D3016-041 SEAT FRAME ASSEMBLY

DRAWING NO. D3016	TITLE SEAT FRAME ASSEMBLY	REV. A	DART AEROSPACE LTD ENGINEERING ORDER	D.E.O. NO. D3016-A-1	SHEET NO. SHEET 1 OF 1	SCALE NTS
DRAWN <i>1</i>	CHECKED <i>UP</i>	MFG. APPR. <i>RE</i>	APPROVED <i>WAP</i>	DE APPR. <i>WAP</i>		
DATE 10.01.29	DATE 10.01.29	DATE 10.01.29	DATE 10.01.29	DATE 10.01.29

TO REVISE D3016-11 SADDLE'S HOLE SIZES

D3016-11 SADDLE

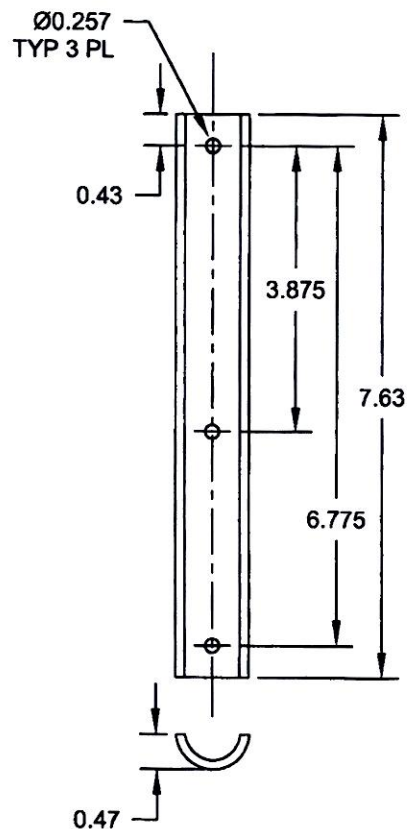
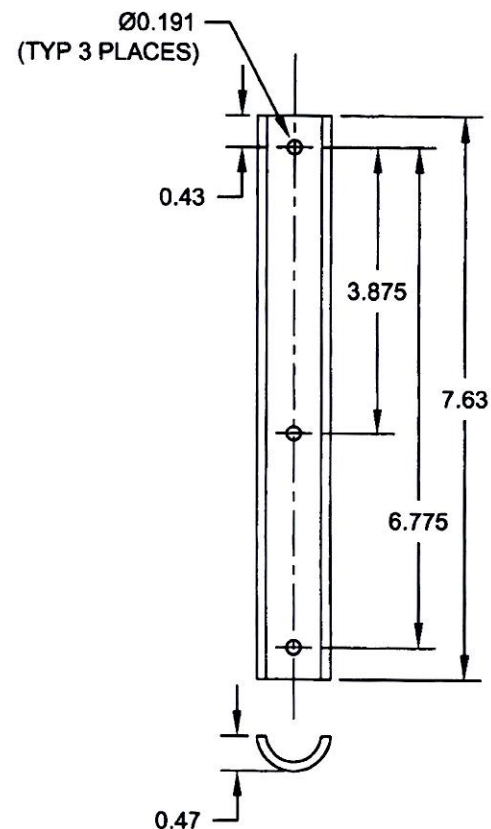
DETAIL D3016-11 SADDLE (SHEET 3): Ø0.257 TYP 3 PL WAS Ø0.191 (TYP 3 PLACES) AS SHOWN:
